Called Planning Commission Meeting

June 25, 2026 6:00 PM

4.I. 3264 Springhaven Drive Site Plan Revision Request

DATE: June 1, 2026
TO: Adrienne Senter
FROM: Lynn Patterson
RE: **Site Plan Review – Stillwood Farms Revised**

Project 190916	Sheet C3
Date 9/16/2019	
Scale 1" = 30'

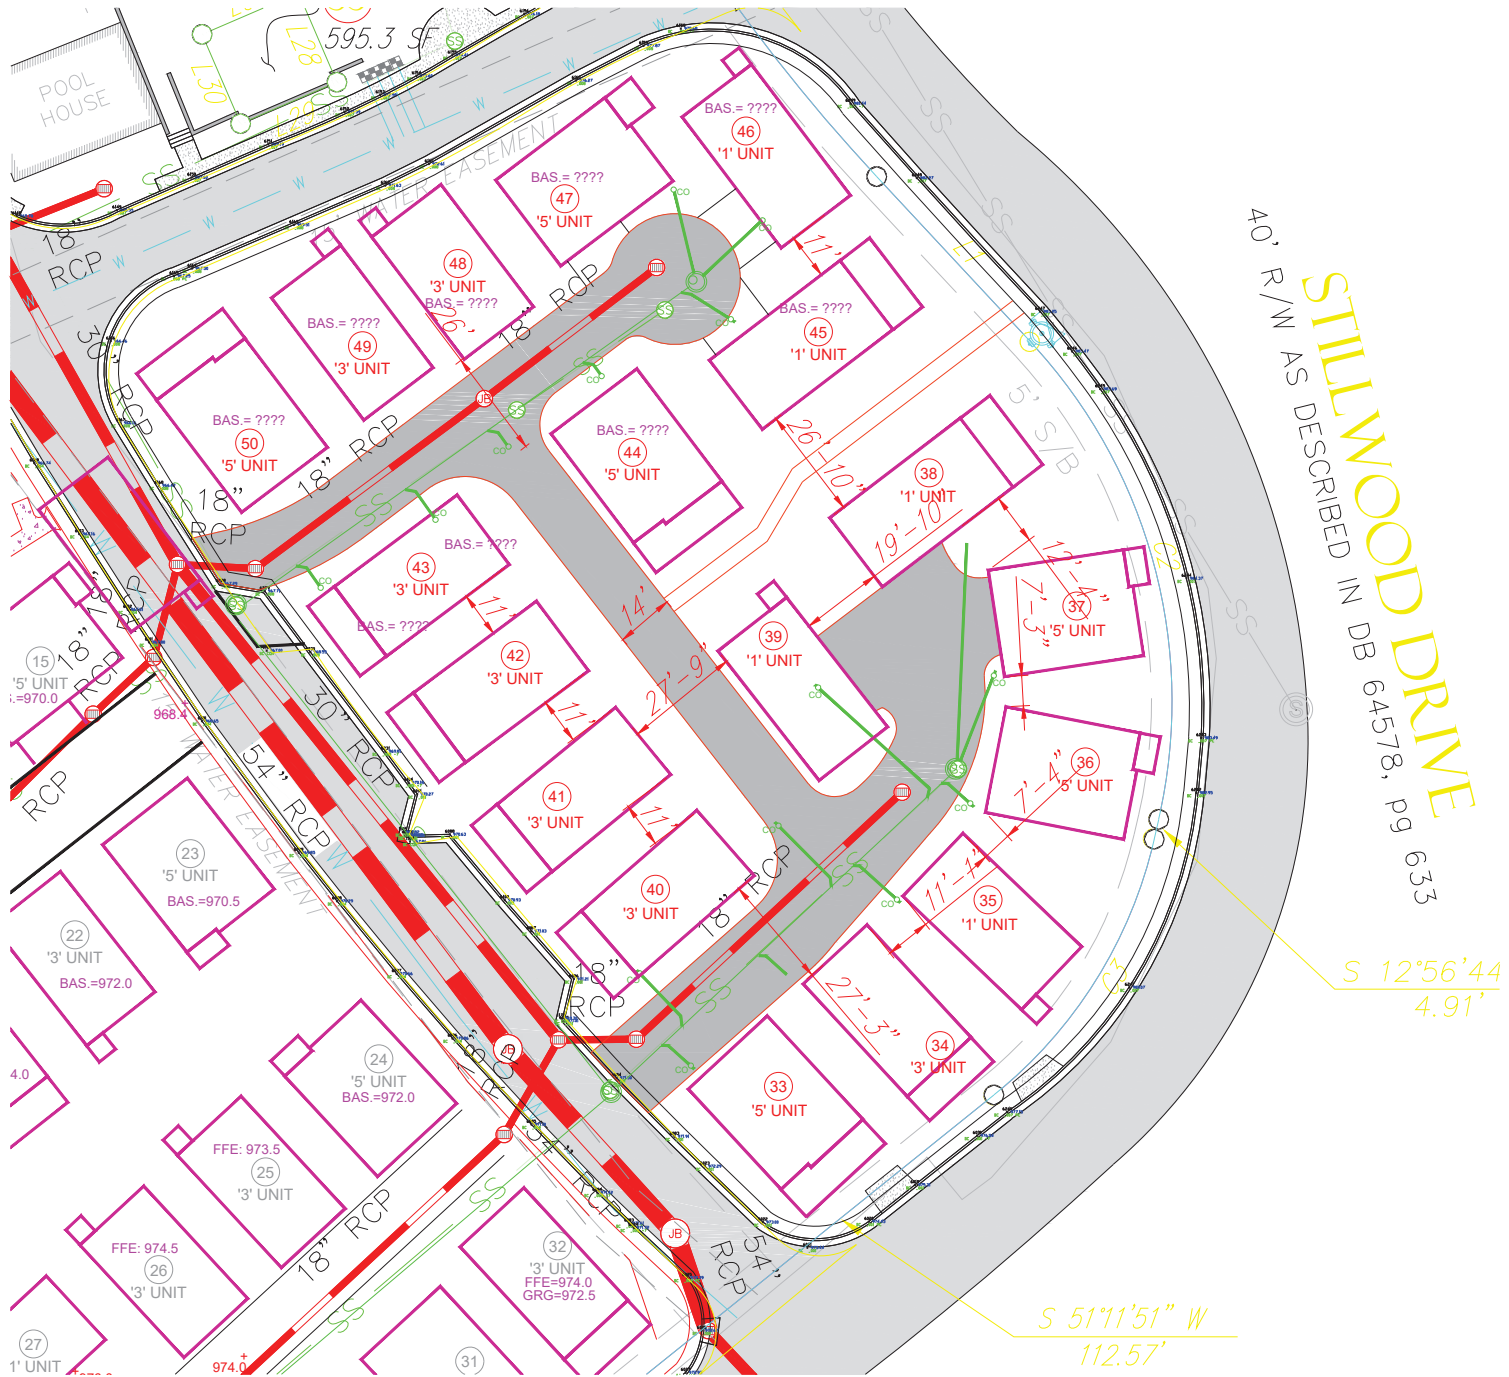
The City of Hapeville has received a revised site plan application from Stillwood Development for a planned unit development to be located on 4.17 acres. The original site included 58 alley-loaded single family units fronting on the adjoining streets or common greenways, a pool, and dedicated greenspace. The proposed revisions in Phase V and Phase VI removes two units and adds a connecting drive between the two internal driveways.

The plans show the location of 56 single family dwellings with a pool and pool house, greenspace, and internal greenways.

Should Fire Marshal find the new design satisfactory with regard to Life / Safety Codes, Design Review Committee and City Staff recommend approval of the revised site plan.

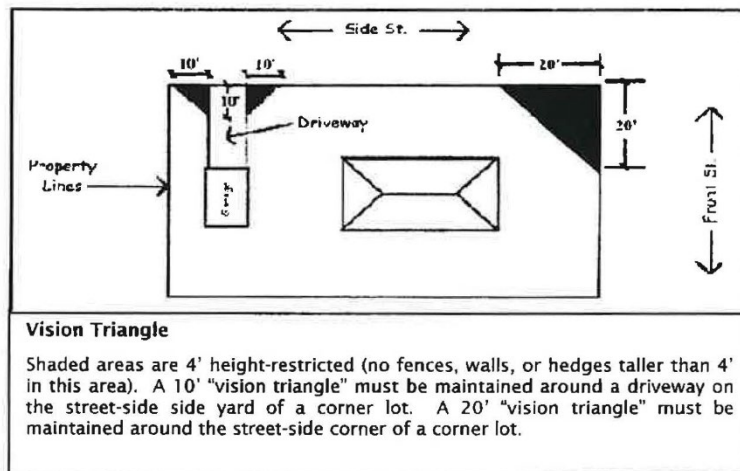
There is an existing chain link fence. Chain link is not permitted in areas visible from the right of way. Should a fence be desired, it must adhere to the following standard:
